RE: **DOCKET NO. 431** – South Norwalk Electric and Water Certificate of Environmental Compatibility and Public Need for the construction, maintenance, and operation of an electrical substation and its connection to an existing 115 kV transmission line, located at 180 Dr. Martin Luther King, Jr. Drive, Norwalk, Connecticut.

## Staff report for partial D&M Plan

## May 16, 2013

Appendix A – Existing Conditions

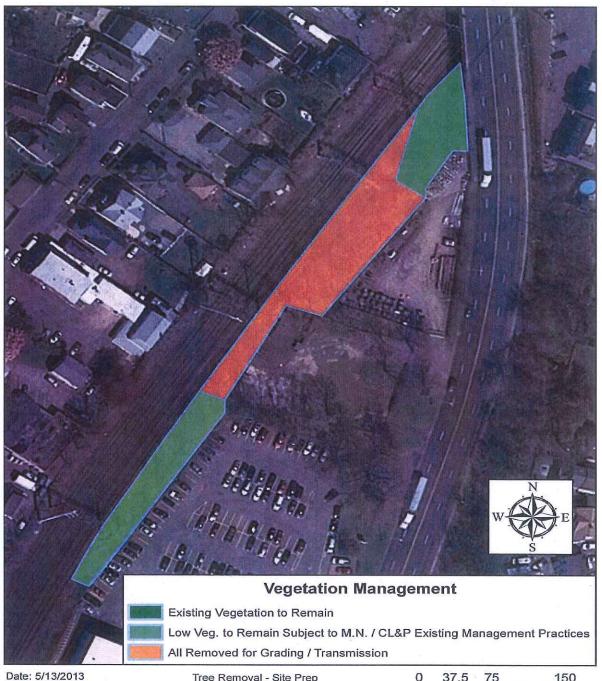
Tree clearing is necessary to accommodate the substation footprint as well as the loop-through transmission connections. Currently, there are trees on the western portion of the site adjacent to the MNRR corridor. According to the attached tree removal drawing, the northern portion of the site (in dark green) would not have any clearing of vegetation. (See Appendix C of this report.) The central portion of the site (in orange) would be cleared for substation grading purposes and to accommodate the transmission connections. The southern portion (in light green) would have limited tree clearing per MNRR and The Connecticut Light and Power Company existing management practices.

All 56 trees in the orange area would be removed. In the light green zone, approximately 35 trees would be removed and 84 would remain. In the dark green zone, all 32 trees would remain. Thus, in total, 44 percent of the existing trees would be removed; thus, 56 percent would remain. There are no plans to landscape the western side of the site given the close proximity to the railroad tracks and the need for clearance for transmission connections.

Thus, staff believes that visual impact mitigation is necessary to soften the direct views of the substation on the west-central (orange zone) portion of the site from the residences on the opposite site of the tracks. Since the tree removal is necessary and landscaping is impractical close to the tracks, privacy slats on the substation's chain link fence would shield the views of much of the substation equipment, except for the structures/equipment that are taller than the fence.

SNEW has agreed to include privacy slats as part of its upcoming full D&M plan which would include the fence plan. As a condition of approval, staff recommends that SNEW include privacy slats as part of the fence plan in the full D&M plan.
